Addendum 134 – Regulation No. 135

Revision 1 - Amendment 1

Supplement 1 to the 01 series of amendments – Date of entry into force: 25 August 2016

Uniform provisions concerning the approval of vehicles with regard to their Pole Side Impact performance (PSI)

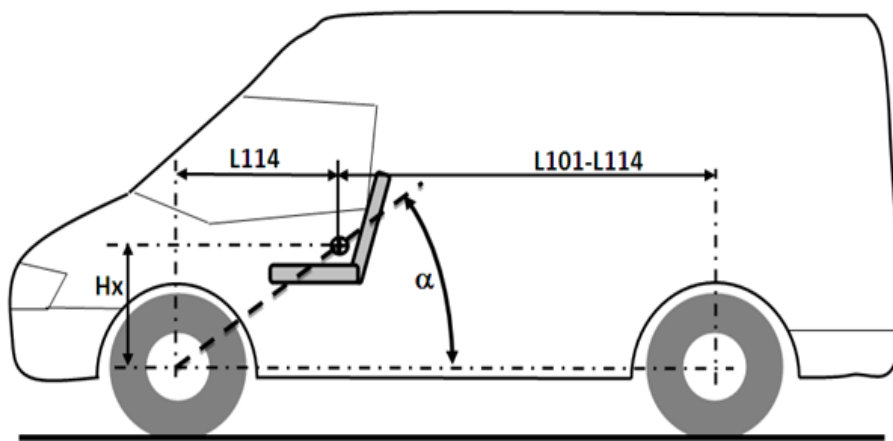
Paragraph 1.1., amend to read:

"1.1. This Regulation applies to:

- (a) Category M₁ vehicles with a gross vehicle mass of up to 3500 kg; and
- (b) Category N₁ vehicles where the acute angle alpha (α), measured between a horizontal plane passing through the centre of the front axle and an angular transverse plane passing through the centre of the front axle and the R-point of the driver's seat, as illustrated below, is less than 22.0 degrees; or the ratio between the distance from the driver's R-point to the centre of the rear axle (L101-L114) and the centre of the front axle and the driver's R-point (L114) is less than 1.30.²
